**Howard County
Health Department**

RECEIPT DATE: 6/18/20 **ONSITE SEWAGE DISPOSAL SYSTEM** P 567881

PROPERTY ADDRESS: 1045 Long Corner Road

TRENCHES:	LINEAR FEET REQUIRED: _____	INLET DEPTH: _____
	TRENCH WIDTH: _____	MAXIMUM BOTTOM DEPTH: _____
	MINIMUM SPACE BETWEEN TRENCHES: _____	EFFECTIVE AREA BEGINNING DEPTH: _____
LOCATION:	TO BE STAKED BY SANITARIAN DURING PRE-CONSTRUCTION INSPECTION.	
NOTES:	<u>Install new 2000g septic tank to meet 5' set back from proposed deck</u>

LOCATION DIAGRAM

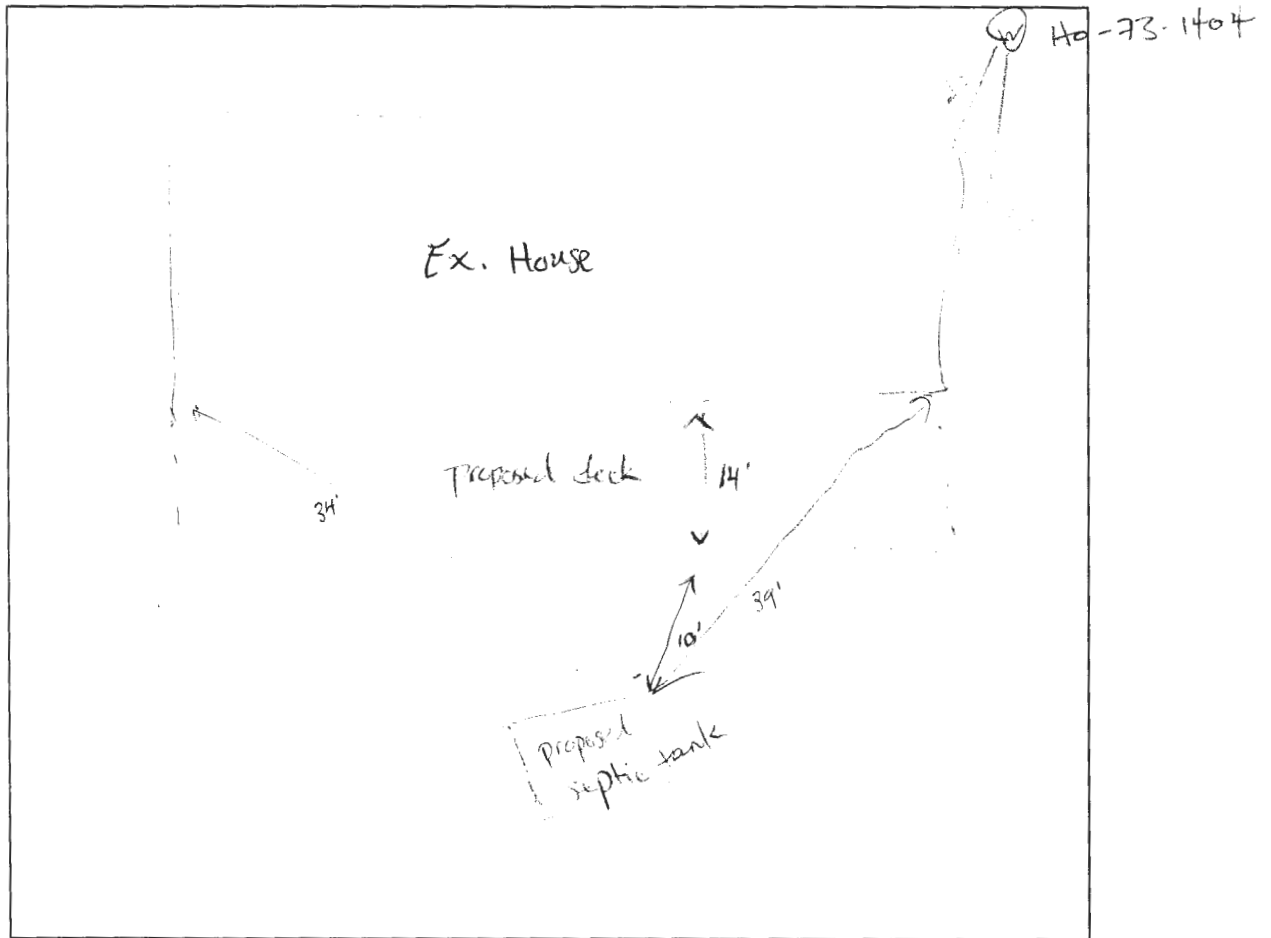
COMMENTS: ^{Proposed} Tank location confirmed to be 10' from
proposed deck.

LOCATION DRAWING

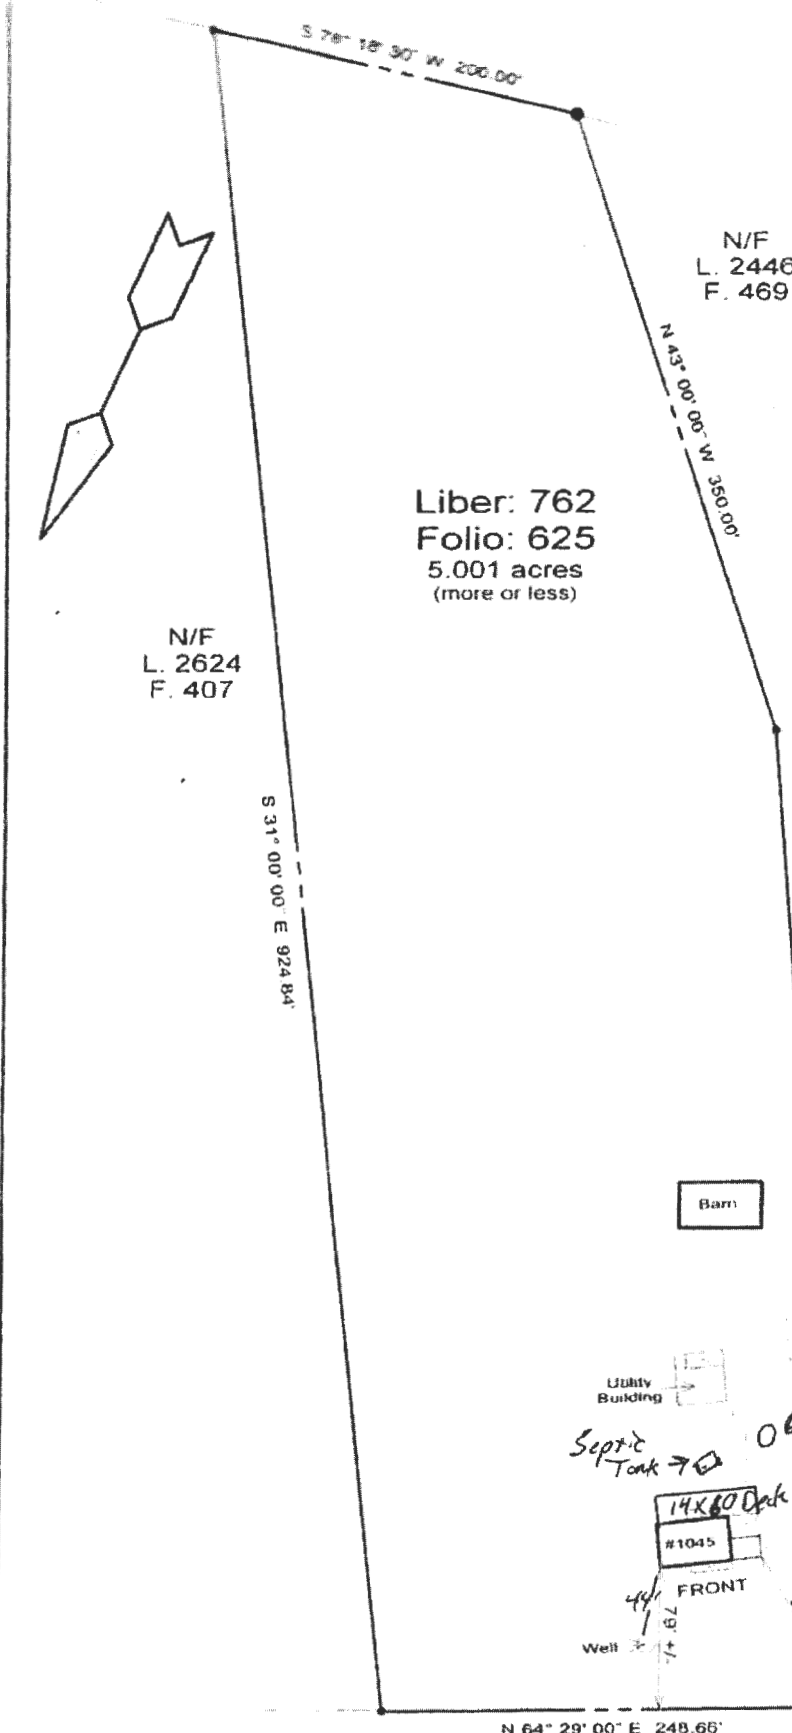
Doug,
This site plan is very vague. It needs to show more detail of the existing septic system, its location, all with respect to distances to the house and your proposed deck addition. You may elect to draw everything to scale if you want. You may want to increase the size of this plat to help you or maybe an insert that is larger.

Pursuant to the approval request for your deck addition, you need to resubmit a drawing (similar to the one you submitted with the original paperwork), which show the lot boundaries, existing house, structures, ex. Septic system components, ex well, proposed addition (to scale or with correct dimensions as such), proposed new septic tank location with elevations. What you have submitted is fine as details of the installation but you need to compose this on an appropriate site plan. This site plan is what I will need to stamp and approve to issue your septic permit. It will also serve as your submittal to the county to obtain your building permit.

I left you a voicemail, cause I wasn't sure exactly what you wanted. The only thing that is changing is the tank location. I have added the location of the existing tank onto this plat plan in red pen for clarification. I also blew it up so you can see it more clearly. Everything was to scale on the last drawing I sent you.
